**MEETING AGENDA
SESSION OF THE HISTORIC PRESERVATION BOARD
CITY OF KISSIMMEE
CITY HALL, COMMISSION CHAMBERS
101 CHURCH STREET, KISSIMMEE, FLORIDA 34741-5054
MONDAY, NOVEMBER 14, 2022 AT 5:15 PM**

ITEM 5.A

721 Mabbette Street - Change of Use - Exterior property improvements

2
A-2
PROPOSED SITE PLAN
SCALE 3/32" = 1'

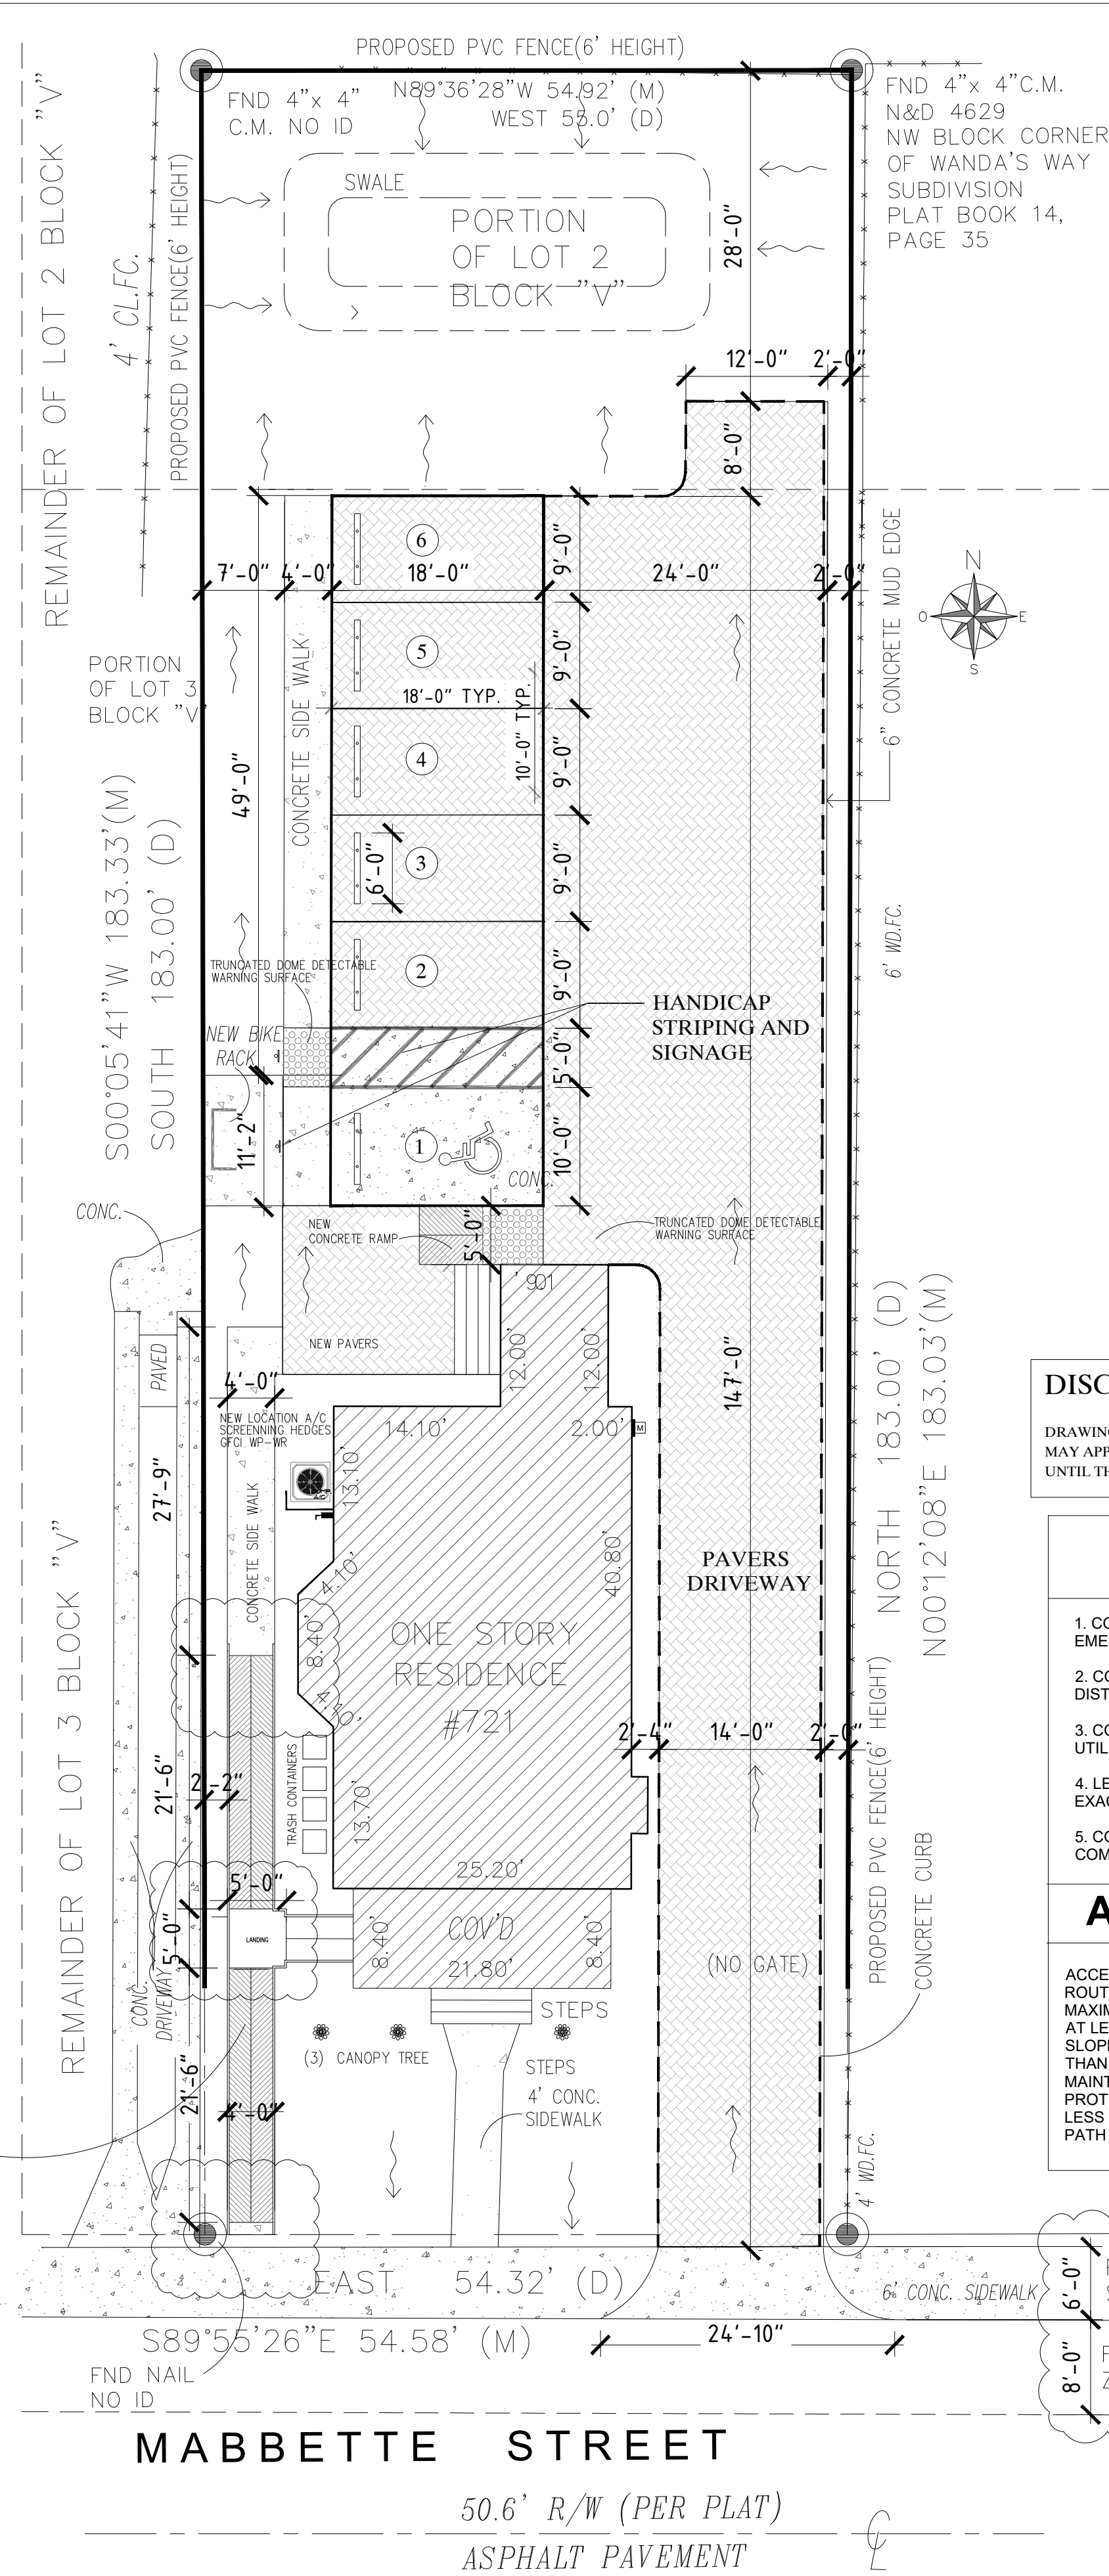
1. Remove the ramp that connects to the sidewalk on Mabbette Street. Like other residential conversions in the area, the ramp should connect to the parking area and have a minimal impact to the integrity of the structure. The ramp should only connect to the parking area and shall not extend in front of the front facade.
2. Slats for the ramp shall match the style of other similar style improvements within the district and be consistent with slat styles appropriate for the bungalow style. Samples have been included in the backup.
